NUMBER: 18-068-16

MIL Illumination: DTCs P112C and/or P112D

2015 - 2016 (KL) Jeep Cherokee

Fig. 1 Old O2 Sensor

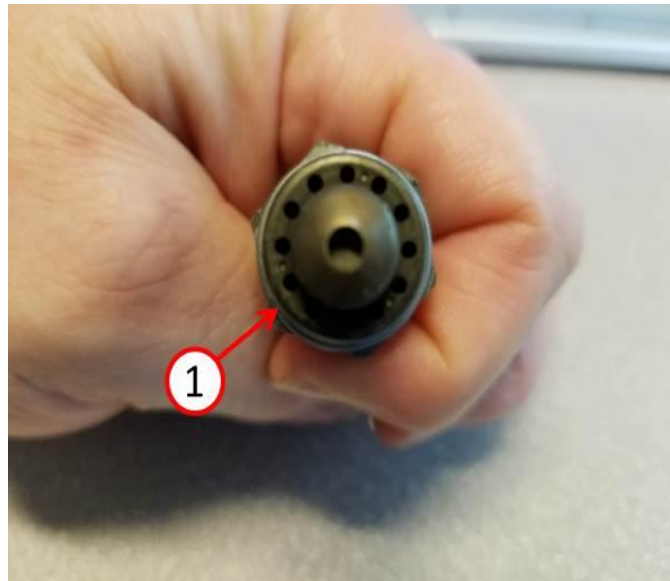
3. Examine oxygen sensor and identify if it is the old design ([Fig. 1](#)) or if it is the new updated design([Fig. 2](#)).

1 - Old sensor (without holes)

1 - New sensor (with holes)

NOTE: The oxygen sensor should only be replaced with the updated design.

4. Is the oxygen sensor that was removed the old design?
 - a. YES>>> Install the new updated design oxygen sensor.
 - b. NO>>> This Bulletin does not apply. Normal diagnosis should be performed.
5. Clear any DTCs that may have been set in any modules.
6. Lower the vehicle. Refer to the detailed service procedures available in DealerCONNECT> TechCONNECT under: Service Info> 04 - Vehicle Quick Reference> Hoisting> Standard Procedure.
